# Delmore Fast-Track

25/06/2025 – Auckland Council Response

**Auckland Transport**

### **DELMORE FAST-TRACK CONSENT - BUN60444768**

Figure 1: NOR 6 Designation Boundary<sup>3</sup> and Section within the Delmore Application Highlighted Indicatively

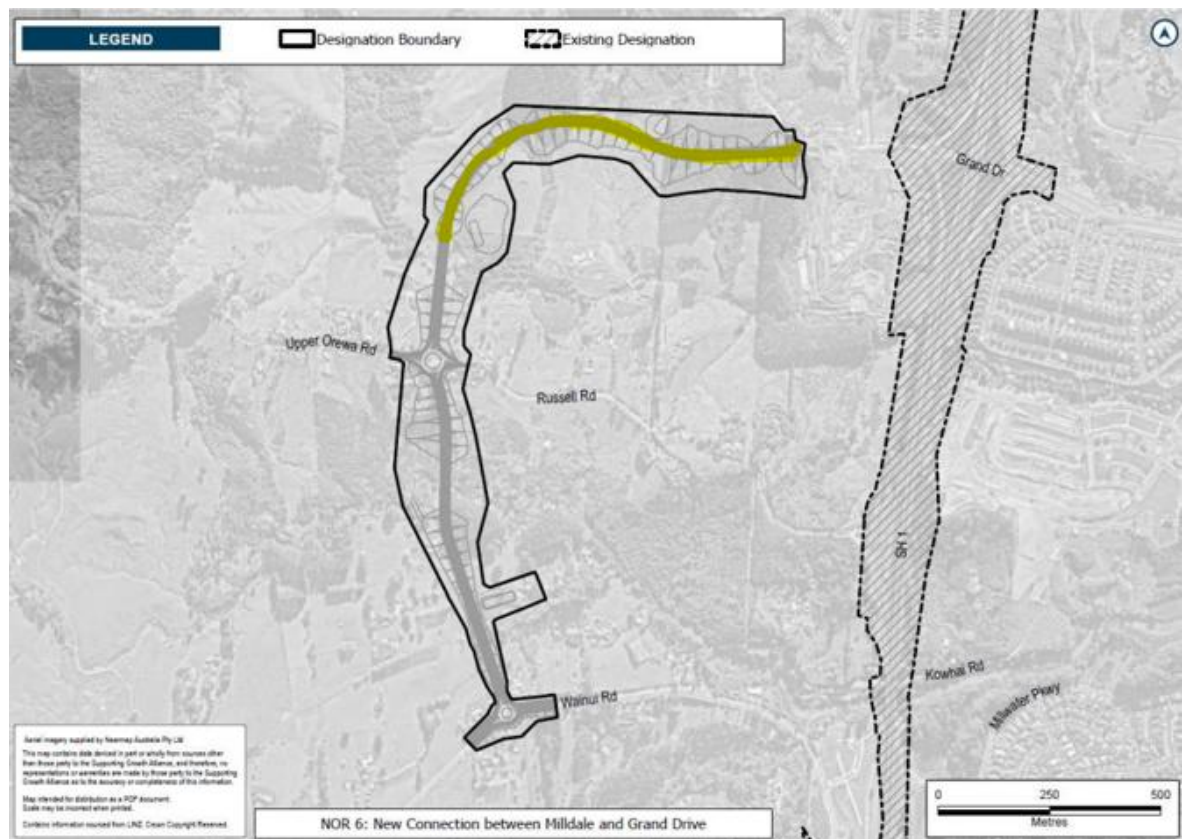
A portion of the NoR 6 designation crosses through the applicant site, and the applicant proposes to construct this section of the road. The following image shows the full NoR 6 designation and the section that would be constructed as part of this application highlighted in yellow.

There is no timeframe for construction of the remaining section of road enabled by NoR 6 outside of this application. The SGA considered a full build out (completion) scenario for the North growth area to be “2048 +”, i.e. meaning development and supporting infrastructure was anticipated to occur sometime beyond 2048, with timing now assumed to be 2050 or later in line with the updated Future Development Strategy. Although that does not mean that individual projects will not be delivered ahead of this time.

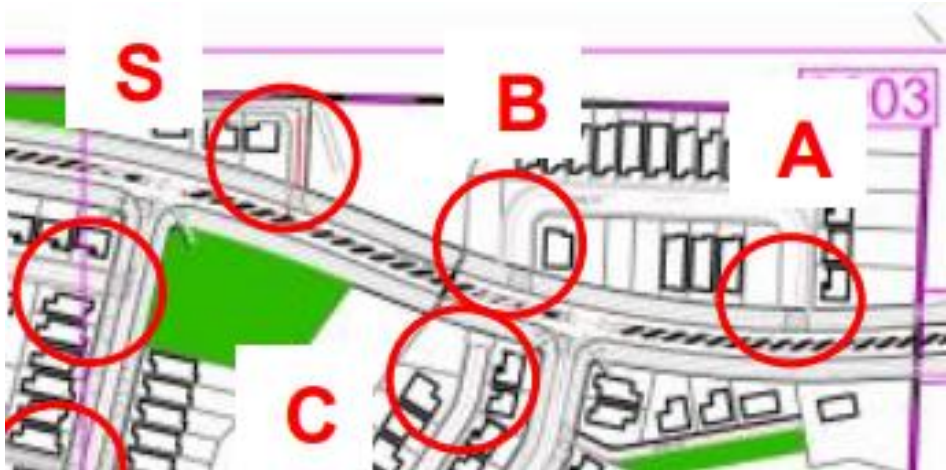
The applicant site layout appears to avoid driveways directly on the NoR 6 road, which is expected for an arterial corridor. A condition to this effect is recommended.

There are however, four Joint Owned Access Lots (JOAL) with direct connection to the NoR 6 road, all within a relatively short section. As shown in the image below (intersections S,B,C,A). There are also two local road intersections in this area.

A proliferation of turning movements in this area, considering the local road intersections as well as the JOALs, will impact on movement along the corridor and could compromise safety, especially for pedestrians and cyclists.

**1.2 NoR 10**

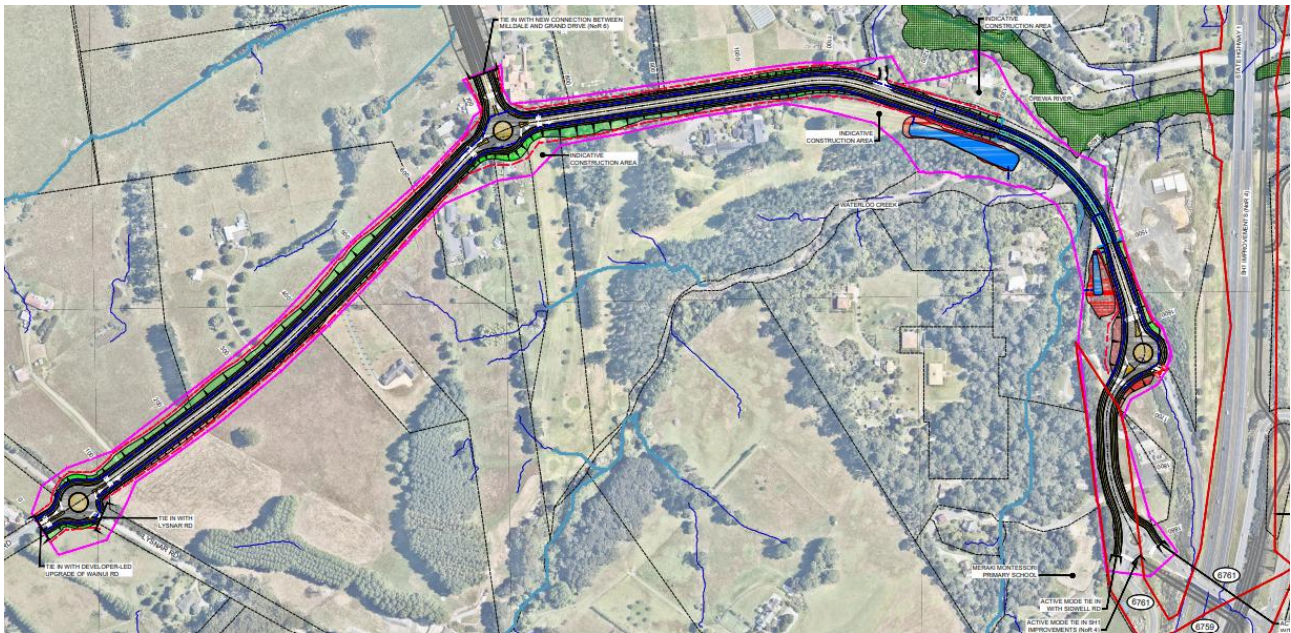
NoR 10 relates to an upgrade of Wainui Road to the south of the applicant site (connecting to NoR 6). The upgrade will improve the existing rural corridor to a 24m urban arterial cross section with separated cycle lanes and footpaths on both sides of the corridor. It includes upgrades to the intersections at Lysnar Road, Upper Ōrewa Road and Kowhai Road.

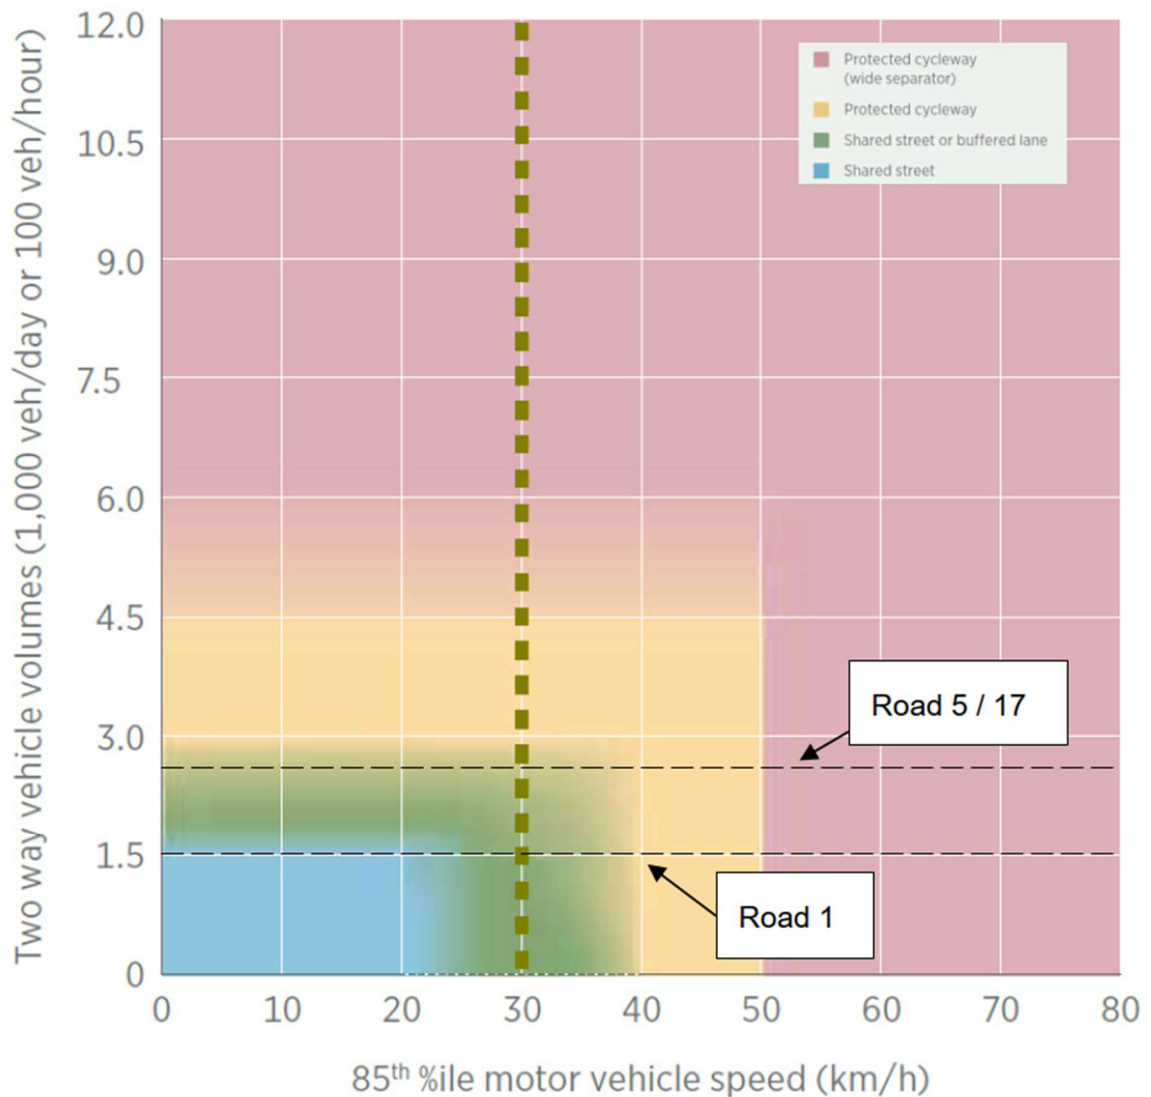
44. The proposed road network lacks the normal road hierarchy as it only has local roads and the NOR 6 arterial road. A more typical road hierarchy includes collector roads which function to collect and distribute traffic between local roads and arterial roads.
45. Appendix 13 of the application included an indicative structure plan for Wainui-Orewa with future collector roads indicated. The structure plan collector roads correspond with the following roads in the Civil drawings and ITA;
  - a. Road 1
  - b. Road 17 Upper Orewa Rd to Road 14 only
  - c. Road 14 from Road 17 to Road 05 only.
  - d. Road 05

46. I consider that the locations of the collector roads indicated in the indicative structure plan are appropriate for the proposal.
47. I also consider that these roads should be designed to allow them to be used as future bus routes. It should be noted that while bus routes and collector roads have many of the same design features they are not the same and Auckland Transport often operates bus services on roads otherwise considered to be local roads, but when this occurs the roads need to be designed to accommodate buses.

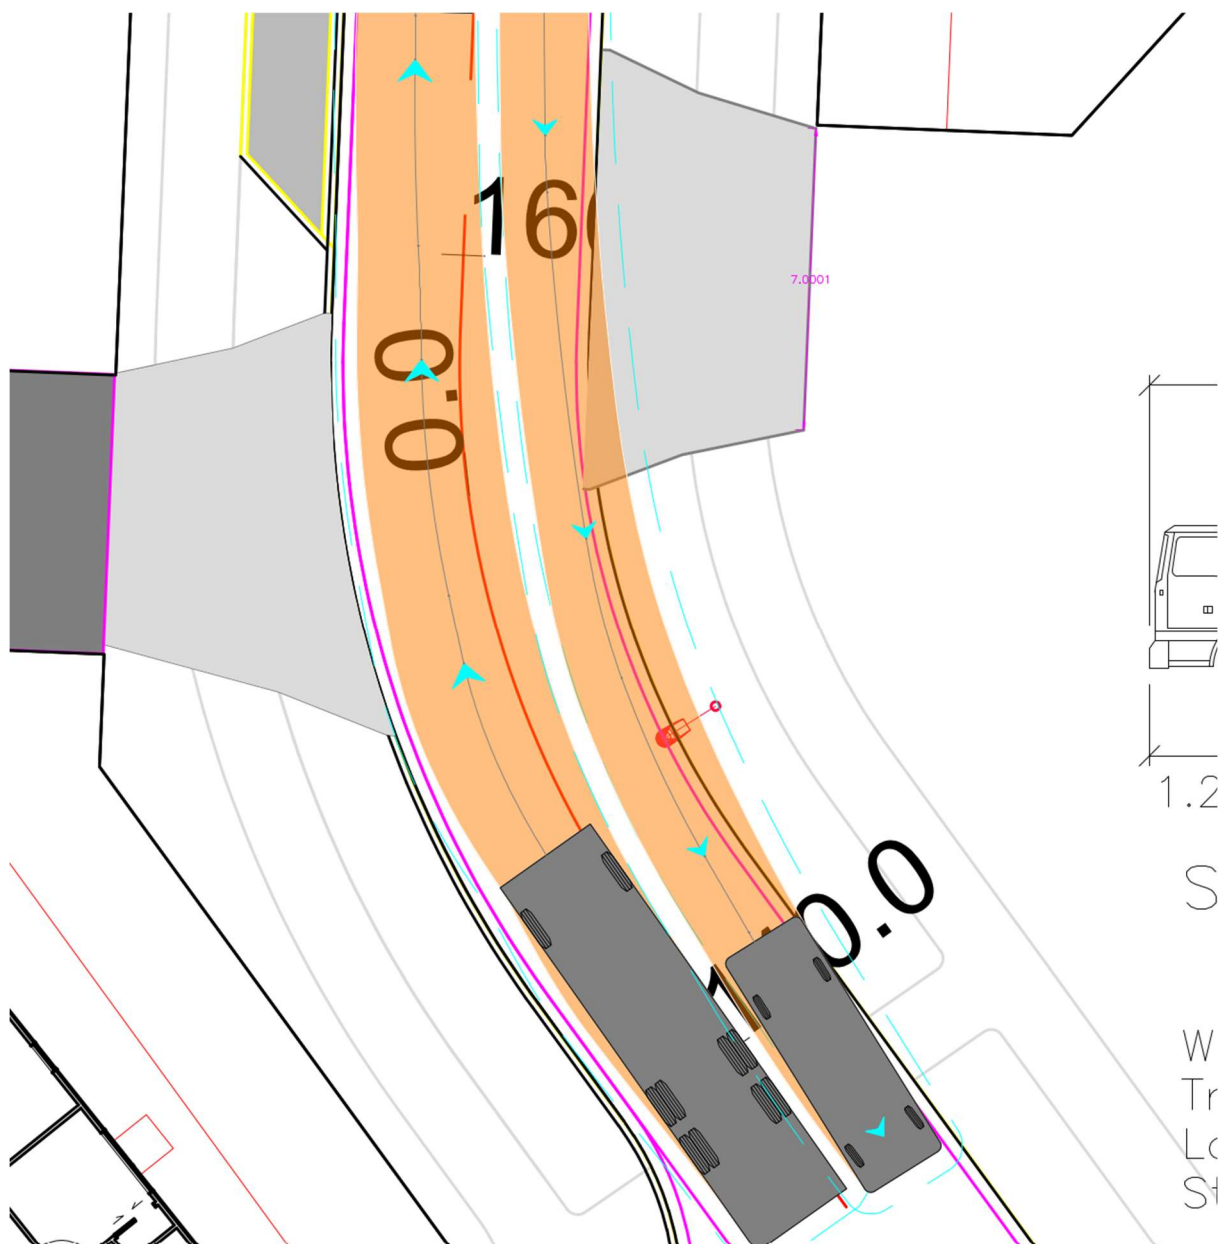
1. Road 01 / NOR 6 Road
  2. Road 05 / NOR 6 Road
  3. Road 05 / Road 14
  4. Road 14 / Road 17
72. These intersections correspond with the collector roads / future bus routes which I discussed earlier in the memorandum. By providing roundabouts at these intersections delays to buses at intersections can be limited, particularly when turning in or out a side road off the NOR 6 Road. This helps provide faster and more reliable travel times for public transport users and helps mitigate the car dependency related effects of the proposed development.

75. The horizontal curve in Road 05 should be straightened out, the curve shown in the drawings increases travel distance, causes visibility issues from driveways, and is a potential loss-of-control run-off-road crash hazard location.

Figure 39. Stage 2 Proposed Local Road Intersection locations

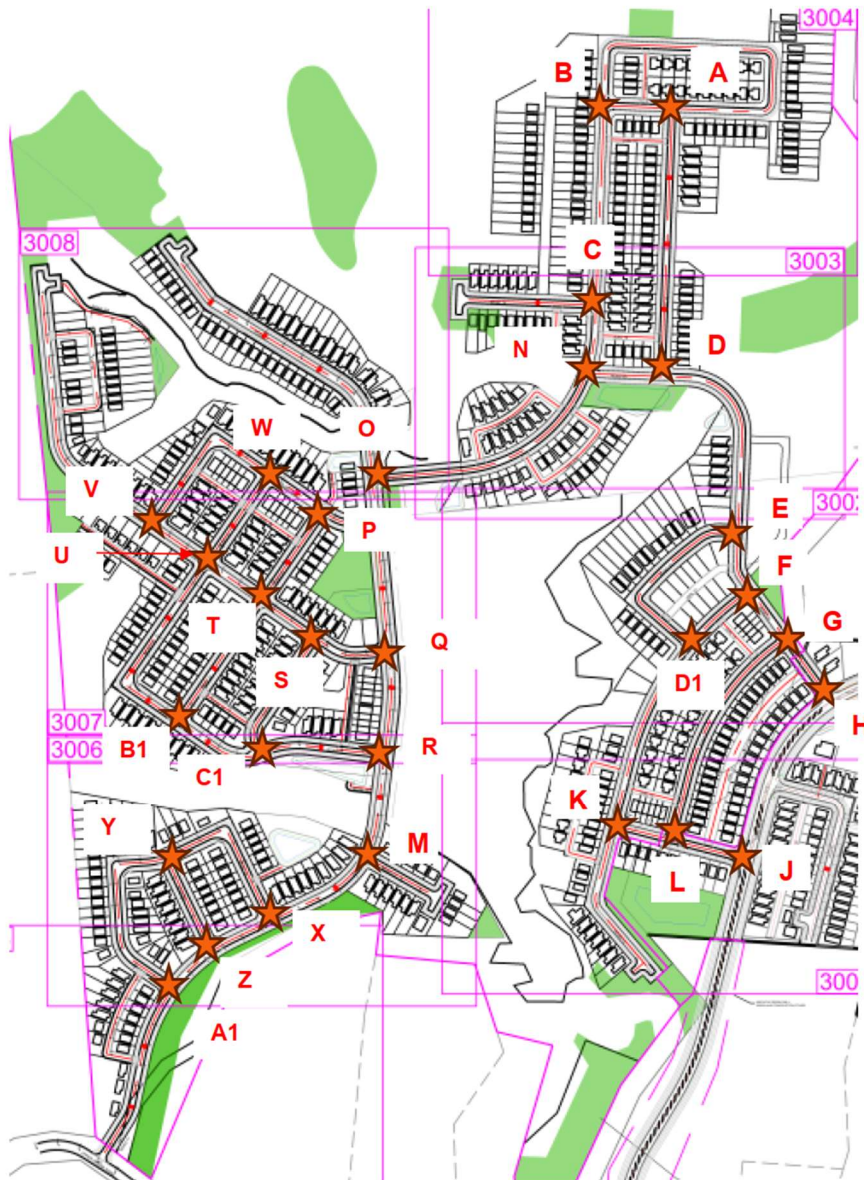
- a. Intersection D (Road 5 / Road 13), refer Drawing SD7.
- b. Intersection E (Road 5 / Road 15), refer Drawing SD8.

In both cases the drawings show areas of non-road reserve land where only low level planting or structures can be located. I recommend that consent conditions requiring a consent notice be placed on the applicable titles be sought in respect of this.
